Title - Sujet Presse-plieuse CNC	
Solicitation No. - N° de l'invitation W0138-20C016/A	Amendment No. - N° modif. 001
Client Reference No. - N° de référence du client W0138-20C016	Date 2020-10-13
GETS Reference No. - N° de référence de SEAG PW-\$QCN-041-17999	
File No. - N° de dossier QCN-0-43049 (041)	CCC No./N° CCC - FMS No./N° VME
Solicitation Closes - L'invitation prend fin at - à 02:00 PM on - le 2020-10-29	Time Zone Fuseau horaire Heure Avancée de l'Est HAE
F.O.B. - F.A.B. Plant-Usine: <input type="checkbox"/> Destination: <input checked="" type="checkbox"/> Other-Autre: <input type="checkbox"/>	
Address Enquiries to: - Adresser toutes questions à: Cloutier, Annabelle	Buyer Id - Id de l'acheteur qcn041
Telephone No. - N° de téléphone (418) 654-6227 ()	FAX No. - N° de FAX (418) 648-2209
Destination - of Goods, Services, and Construction: Destination - des biens, services et construction:

**CNC Press-brake
Bagotville, Quebec**

Amendment 001

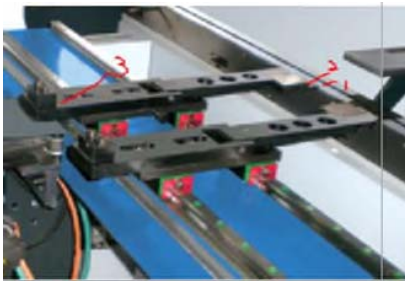
Run of the X backstops - total displacement. Tower back gauge are more convenient because they support the material. We suggest that you specify a tower back gauge (see photo, three point of support in red). Our folder are standardly equipped with a tiered stop with possible support at 39,3 inches.

Do you accept tower back gauge?

Answers: Yes, we accept tower back gauge.

Point 1 and 2:

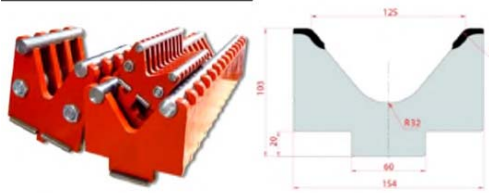
We suggest you ask for 4 sections of 835mm - 1 x 805mm sectioned (pre-cut) if you plan to fold 10' length regularly. This will prevent you from handling cut sections frequently (less setup time). This applies to points 1 and 2 only.

Answers: See the amended Requirement.
